ITEM E6 - Tulin West Highlands Replat 2022

KPB File # 2022-019

TULIN WEST HIGHLANDS REPLAT 2022

STAFF REPORT

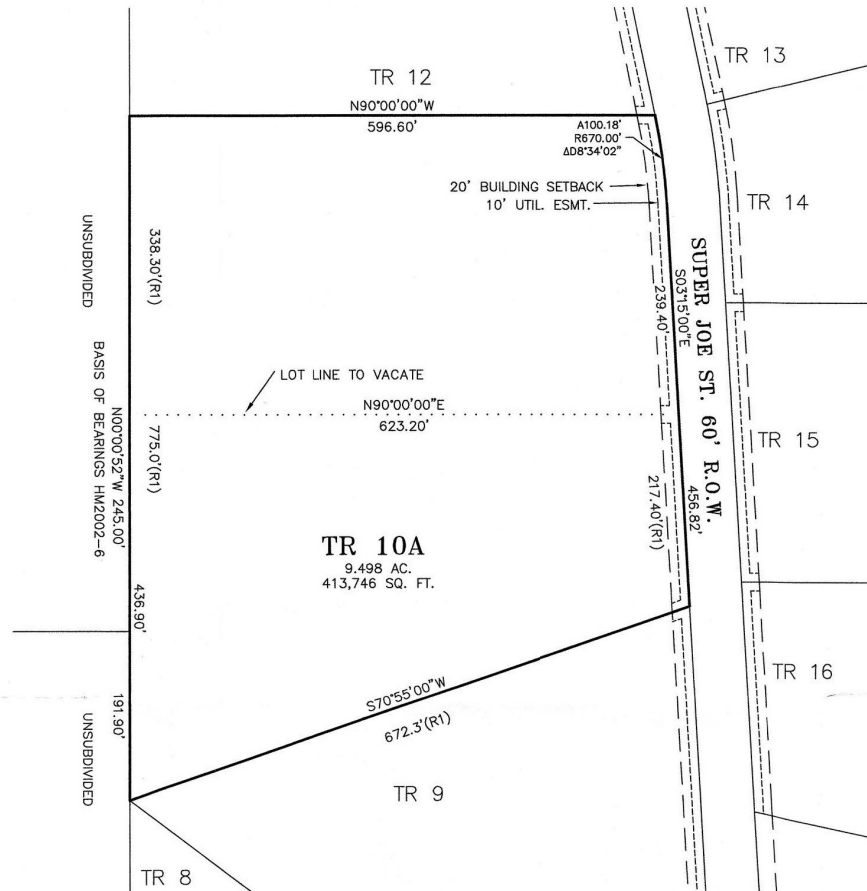
It was not disclosed if a field survey is being performed with this plat. Per KPB 20.60.200(A), a field survey is not required when eliminating existing property lines. If a field survey is not performed **staff recommends** a plat note be added stating one was not performed as permissible by KPB 20.60.200(A), that source of all record data be noted, computed data be noted, and legend note shows record monuments.

Utility Easements The parent plat granted 10 foot utility easements adjacent to dedicated right of ways that increased to 20 feet within 5 feet of the side lot lines. The utility easements are correctly depicted. **Staff recommends** the plat note include the easements were granted by the parent plat or labeled as such on the plat.

- Staff recommendation:** Update the spelling of "Subdivision" and remove the close quote marks in front of "Tulin".
- C. The location, width, and name of existing or platted streets and public ways, railroad rights-of-way, and other important features such as section lines or political subdivisions or municipal corporation boundaries abutting the subdivision;

- Staff recommendation:** Update the street name to Joe Super Street.
- D. A vicinity map, drawn to scale showing location of proposed subdivision, north arrow if different from plat orientation, township and range, section lines, roads, political boundaries, and prominent natural and manmade features, such as shorelines or streams;

- Staff recommendation:** Provide a label for the range.

Staff recommendation: *If the lots depicted are not from the same parent plat as the subdivision the subdivision name or plat recording number should be included. Lot 8, located south of the subdivision, was replatted and is now Lot 8B as found on plat HM 2004-32.*

- *The certificate to plat was not submitted at time of review. Additional plat notes may be required.*
- *Plat note 4 may be removed, as there are no new dedications proposed.*
- *In plat note 5, add "and" between "size" and "may".*
- *Other plat notes mentioned within the staff report.*
- *Add to plat note 2 "Granted by Plat HM 2002-6" unless noted on the utility easement depiction.*
